# PERMIT

SEWAGE DISPOSAL SYSTEM

SUBDIVISION Pheasant Landing ROAD 4505 Linthicum Road LOT 20

TITLE: <b>GRADING STUDY</b>				
PROJECT: <b>LOT 20 - PHEASANT LANDING</b>				
LOCATION: <b>9TH ELECTION DISTRICT TAX MAP 28 HOWARD CO., MD.</b>				
SCALE: 1"=100'	DESIGNED BY: J.T.N.	DRAWN BY: M.A.	CHECKED BY:	DATE: APRIL, 1986
FIELD BOOK:	PAGE NO.:	JOB NO.: 8664	DRAWING NO.: 1 OF 1

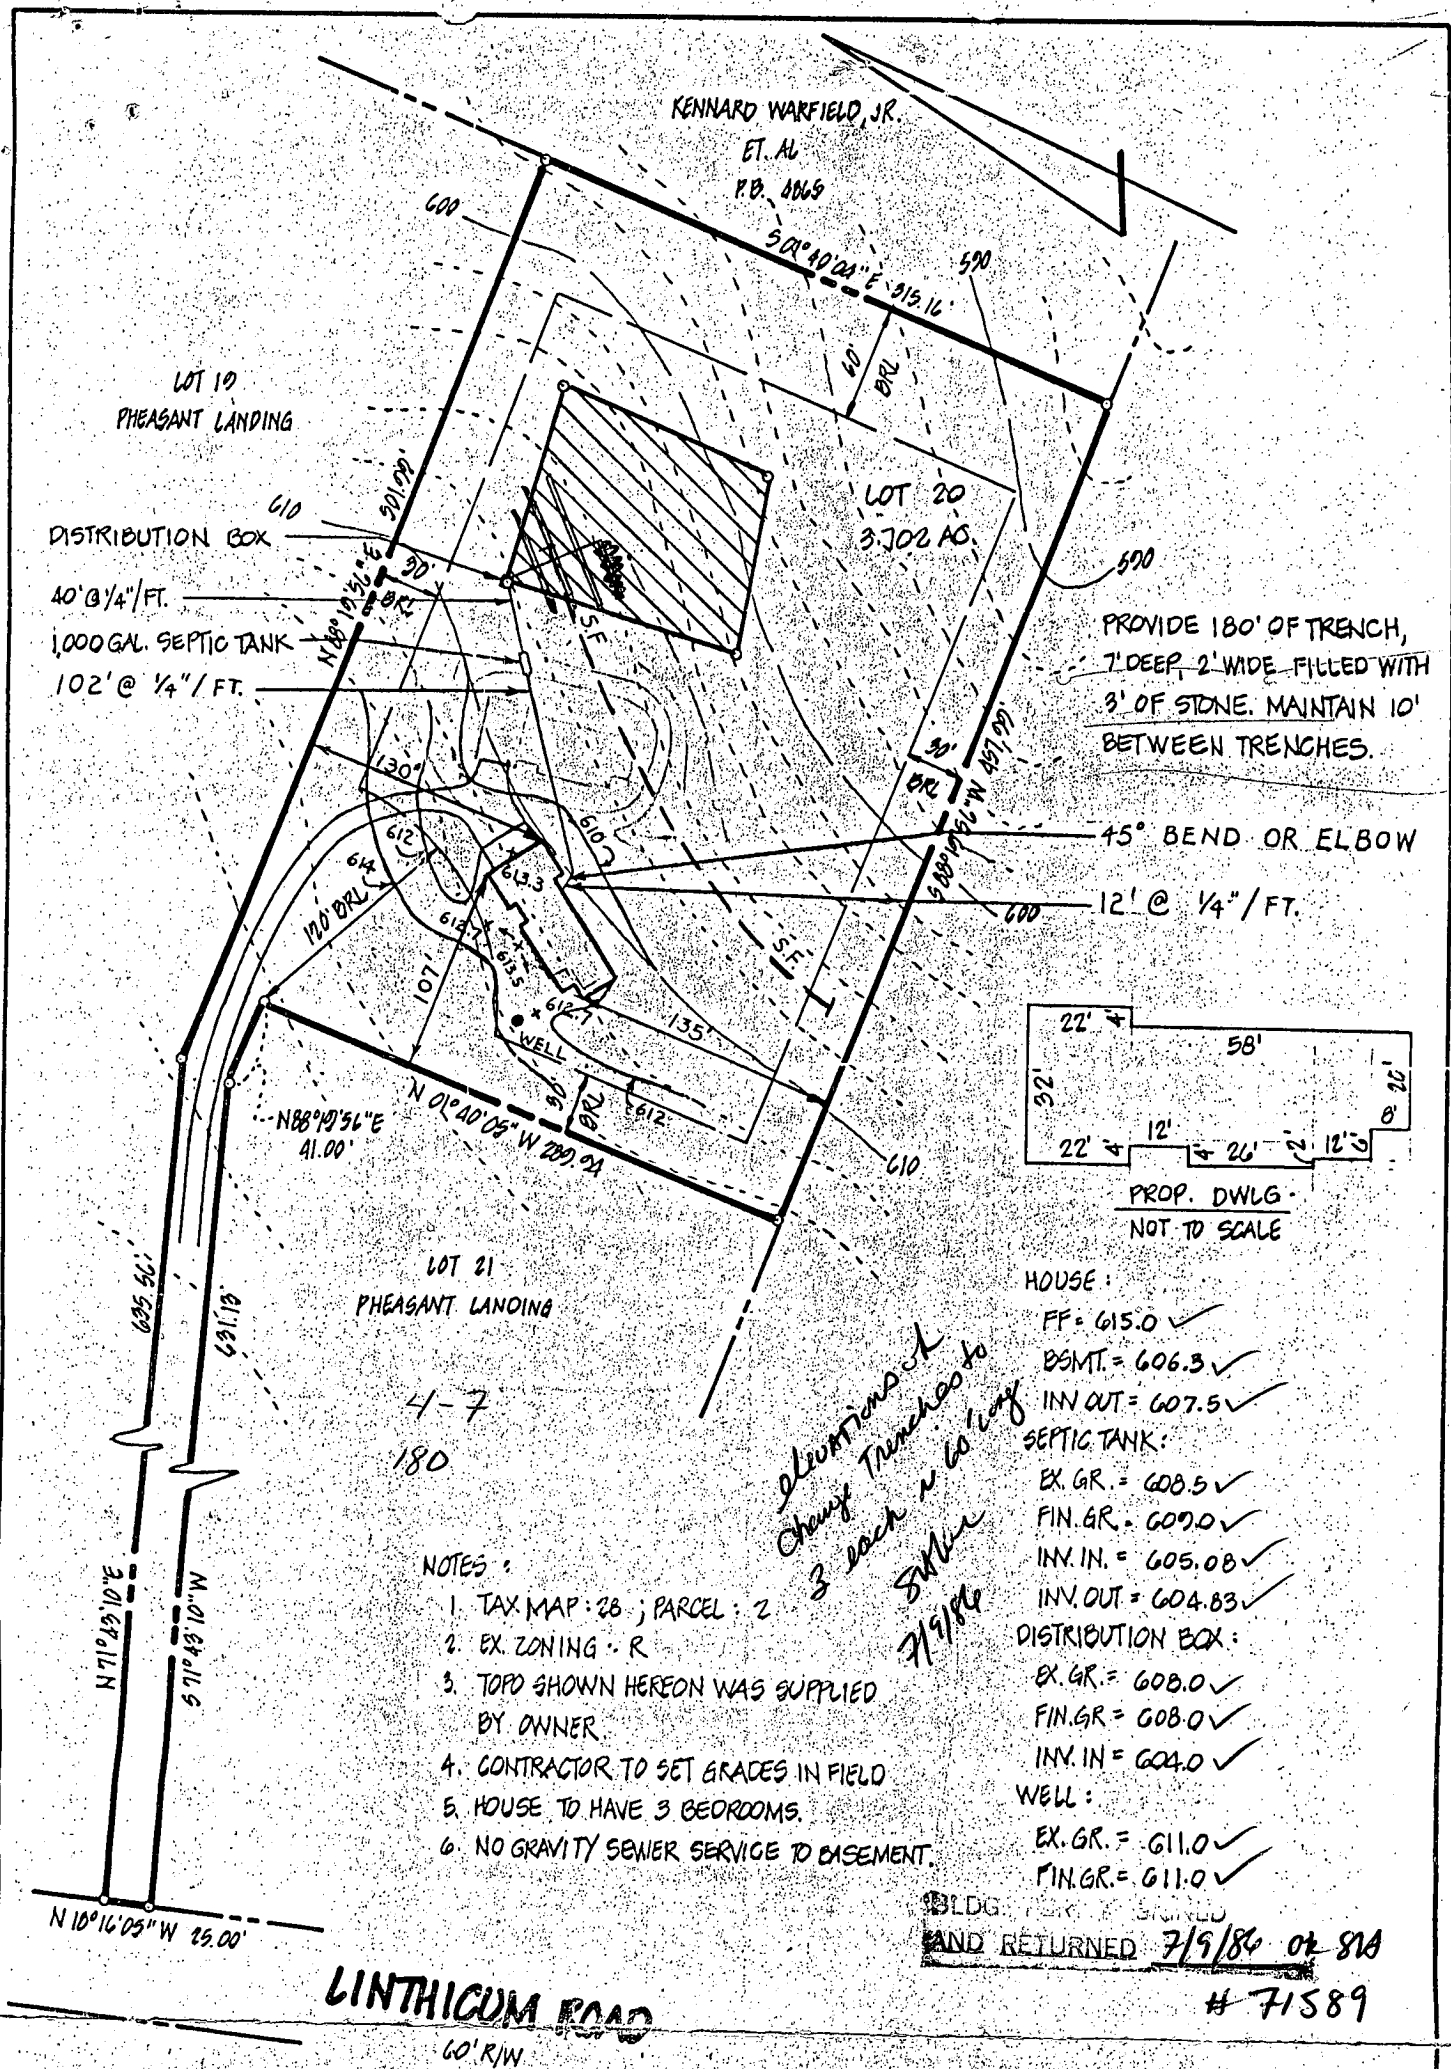
(540 REQUIRED BUT TRENCH ONLY 2 1/2" WIDE RH)

REMARKS 12/17/86 OK TO MOVE TANK FARTHER FROM HOUSE THAN SHOWN ON PLANS RH

12/31/86 - 2 TRENCHES 7' DEEP OK TO ADD GRAVEL. CW 1/2/87 - OK TO COVER

TANK TO BOX TRENCHES 9 1/2' TO 7' DEEP 18" STONE NEEDED

1/7/87 OK TO COVER. SYSTEM EXTRA LARGE BOT TRENCH MARK

*Eliminate  
Cherry Trenches to  
3 each ~ 60' long  
S.M.A.  
7/9/86*

PROVIDE 180' OF TRENCH,  
7' DEEP, 2' WIDE FILLED WITH  
3' OF STONE. MAINTAIN 10'  
BETWEEN TRENCHES.
